PERMIT

SEWAGE DISPOSAL SYSTEM

HOWARD COUNTY HEALTH DEPARTMENT

SUBDIVISION Holly Hills LOT 8 ROAD 3327 Sang Road

PROPOSED GRADING REVISION / SOA

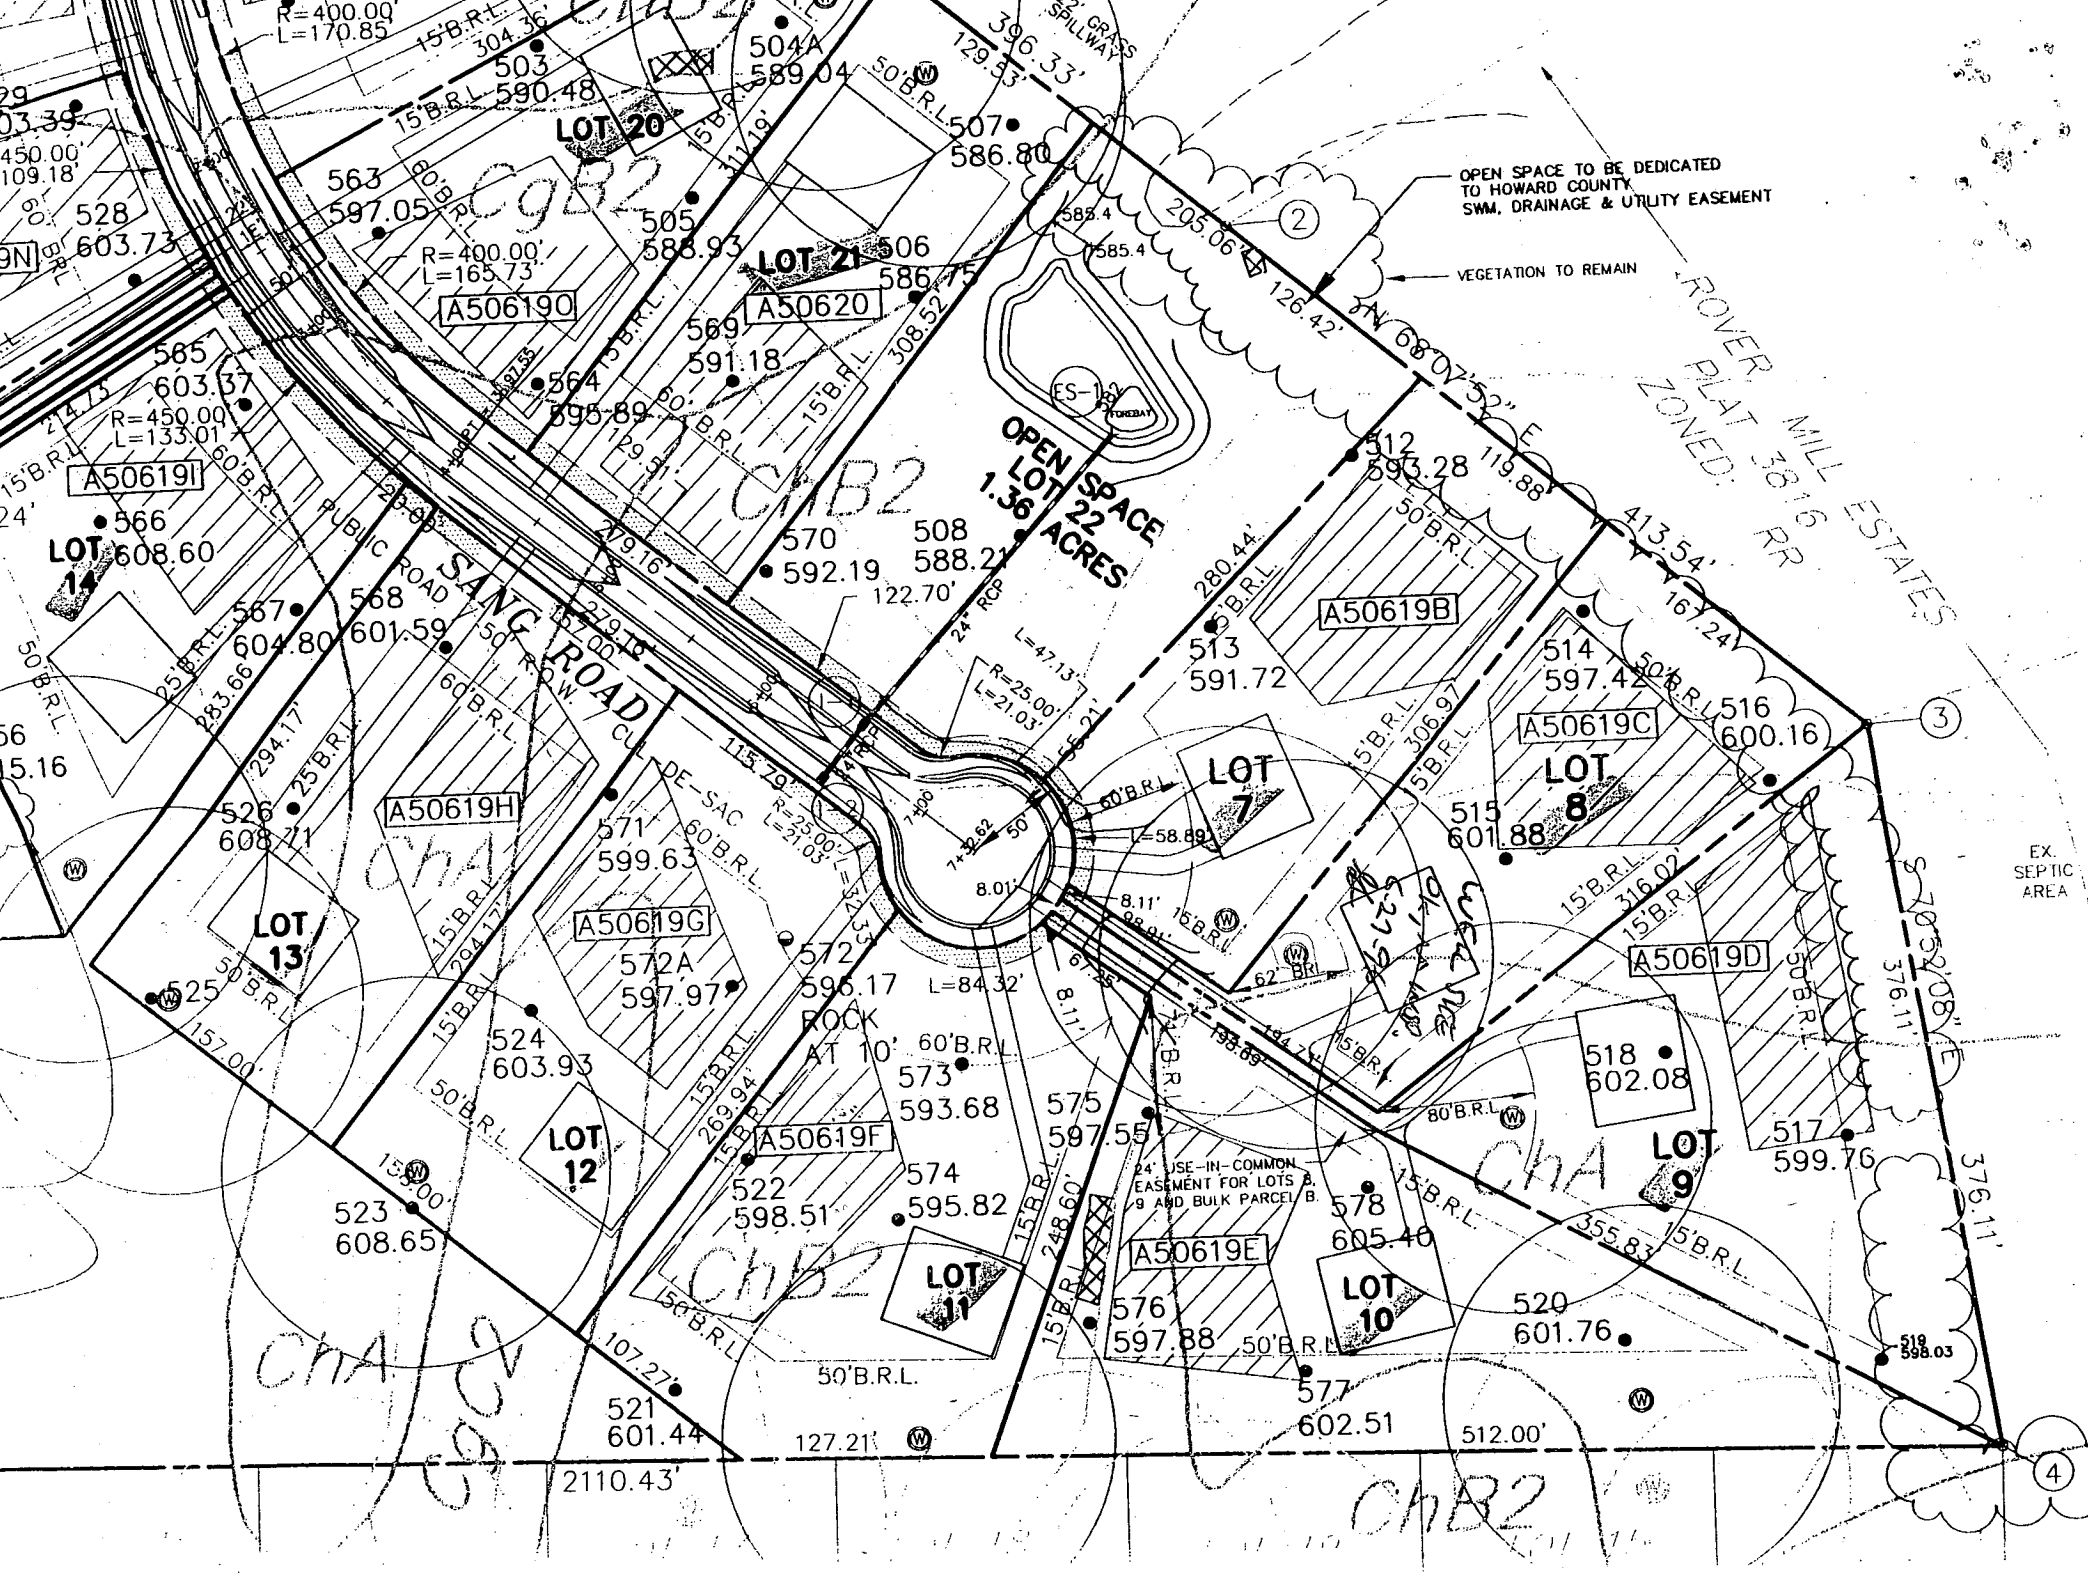
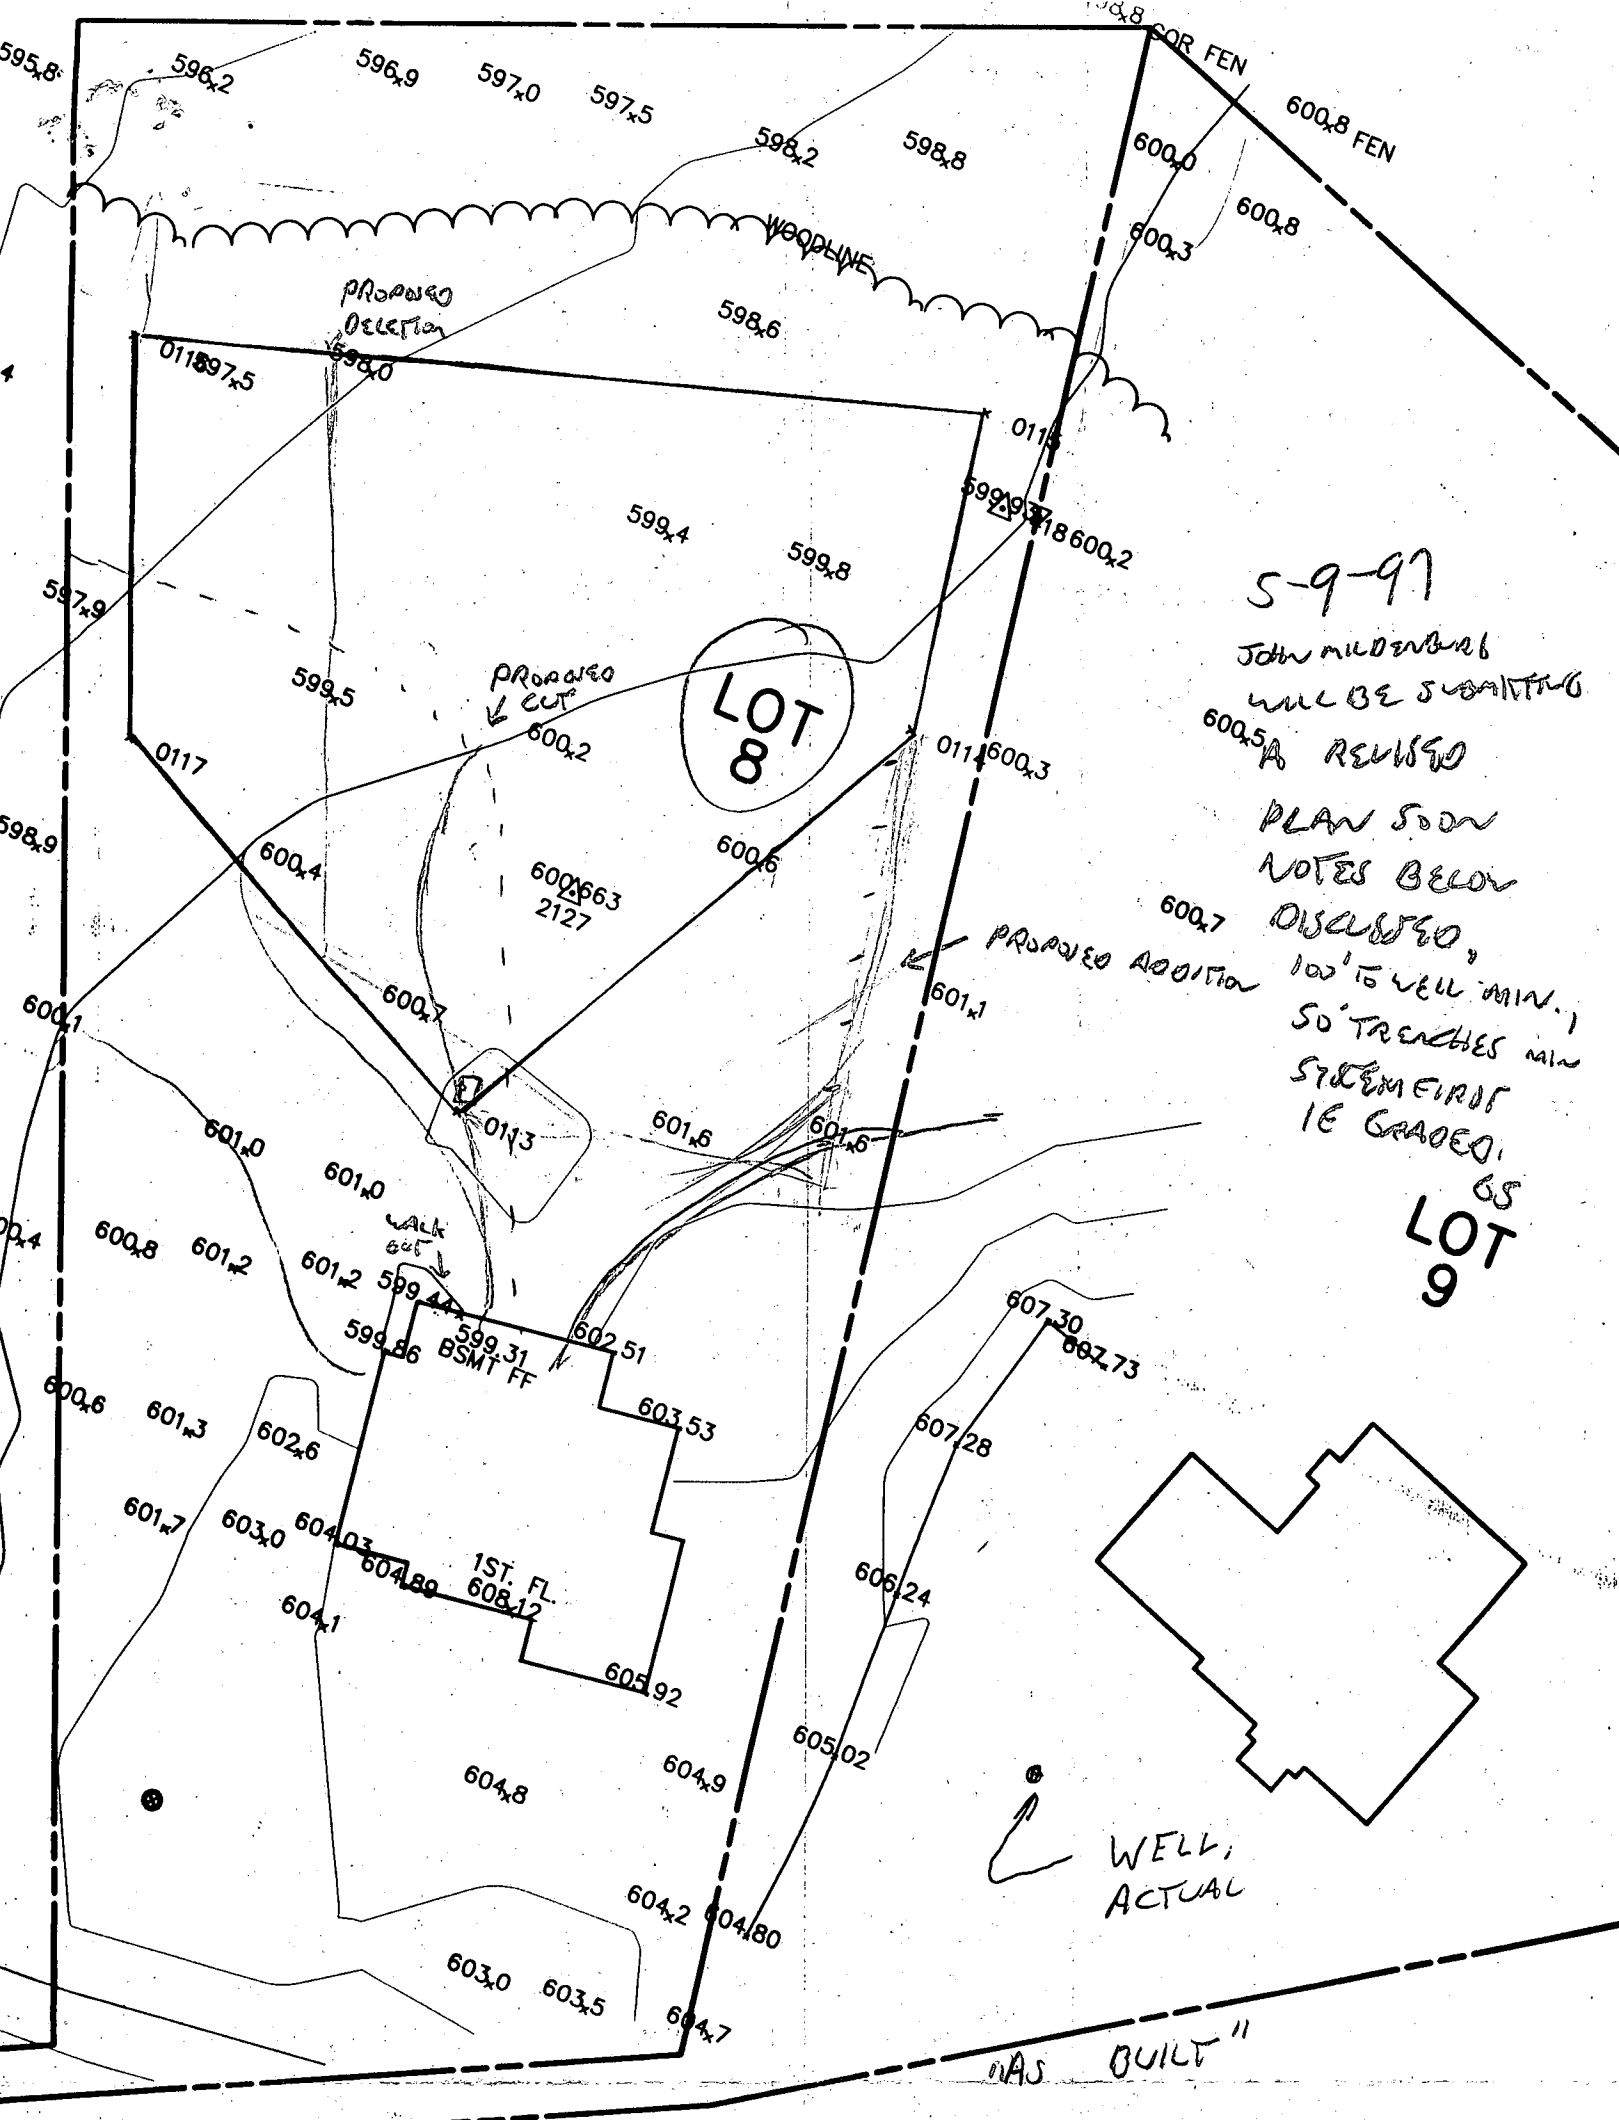
5-9-97
 JOHN MILDENBERG
 WILL BE SUBMITTING
 A REVISED
 PLAN SOON
 NOTES BELOW
 DISCUSSED
 100' TO WELL MIN. 1
 50' TRENCHES MIN
 SYSTEM FIRST
 IE GRADED
 AS
 LOT 9

REVISION TO ACCOMMODATE WALK OUT BASEMENT THAT IS TOO DEEP
 JOHN MILDENBERG TO SUBMIT LOCATION FOR WELL ON LOT 9

PROPOSED GRADING OK, ADVISE INSTALLING SEPTIC SYSTEM EAST ADJUSTING
 SOA TO BETTER MATCH EXISTING SITE CONDITIONS IF IT IS RECONFIGURED
 MINIMAL RESTRICTIONS AS TO SOA RECONFIGURATION, REARWARD OK - WILL HAVE TO
 CUT TREES FOR REPAIR, IF SOA IS MOVED FORWARD TOWARDS THE RIGHT
 FRONT CORNER OF LOT ~~THE~~ POTENTIAL ADDITION AREA WILL BE LOST.
 - NEED REVISED PLAN ~~BY~~
